**FINAL
ENVIRONMENTAL
IMPACT REPORT:
DIABLO GRANDE
SPECIFIC PLAN**

**DIABLO GRANDE SPECIFIC PLAN FINAL ENVIRONMENTAL
IMPACT REPORT**

This Response to Comments Addendum to the Diablo Grande Specific Plan Draft Environmental Impact Report (DEIR) presents the written comments received on the DEIR along with responses to each comment. The DEIR was circulated for public review from September 4 to October 19, 1992. During the review period, the Lead Agency (Stanislaus County Department of Planning and Community Development) received several letters containing comments on the DEIR. All written comments received by the lead agency regarding the adequacy and accuracy of DEIR are presented in this document. Oral public comments also were received at a public meeting on October 1, 1992.

Figure IV.E-1

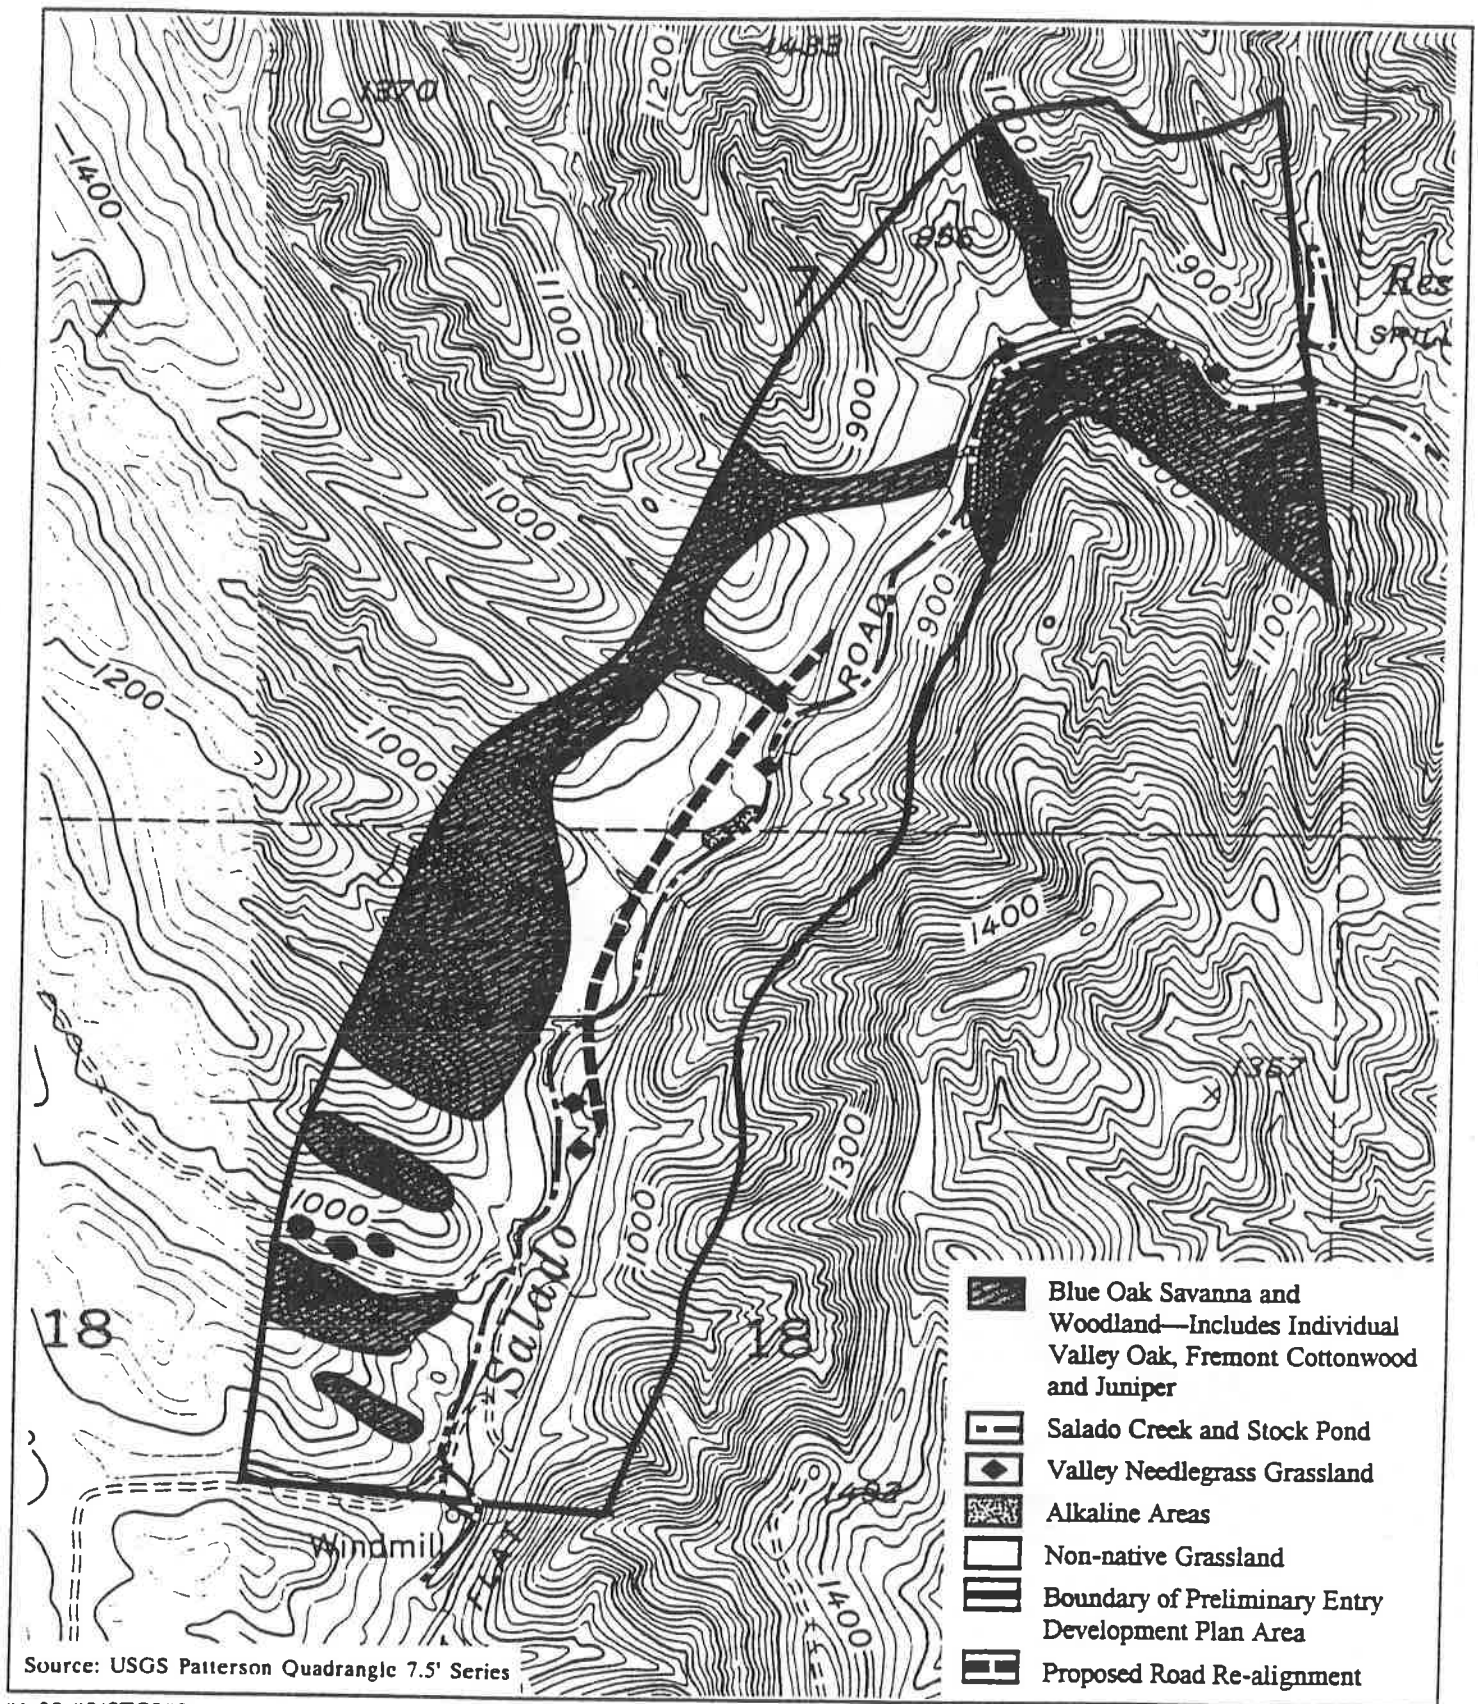
1. Biological surveys of the site have been inadequate to address project impacts. No surveys were conducted for the presence of sensitive plants or animals on site, with the exception of surveys on portions of the project site for San Joaquin kit fox (*Vulpes macrotis mutica*). 1
2. Biological resources are described in a cursory manner. No maps are provided showing the biological resources. No quantification of the acreages of wetland and other wildlife habitats on site or the amounts which may be impacted. 2
3. The mitigation plan contains no specific measures to avoid, minimize, or compensate adverse impacts to biological resources. 3
4. No analysis of the cumulative effects of this project combined with other proposed projects in the region is provided. 4

Page IV-109. Plants. Impacts on sensitive plant species are not adequately addressed. Surveys were not conducted for sensitive plants; therefore, no impacts can be identified or quantified. The Service recommends that a complete botanical inventory be taken of the project site. Special attention should be paid to searching for the species listed in Enclosure A but surveys should not be restricted to those species. Botanical surveys should be conducted by a qualified botanist at intervals throughout the growing season,

New Figures IV.E-1, IV.E-2, and IV.E-3, attached, showing the locations of habitat types in the Phase I and primary access areas, are added to the EIR as follows. On page IV-102, line 22, add the following text (in bold):

Habitats in the Phase 1 area (Oak Flat Valley) are shown in Figure IV.E-1. Habitats include approximately 1,625 acres of non-native grassland; 565 acres of blue oak savanna and woodland; 5.6 acres of Diablan sage scrub (dominated by California sagebrush (*Artemisia californica*); and, approximately 7.1 acres of riparian areas (including 5.4 acres of drainages and 1.7 acres of stock ponds). Areas of valley needlegrass grassland, rock outcrops and alkaline areas are present primarily within the Salado Creek drainage channel and include less than two acres. The blue oak savanna present on the site is open, with widely spaced trees.
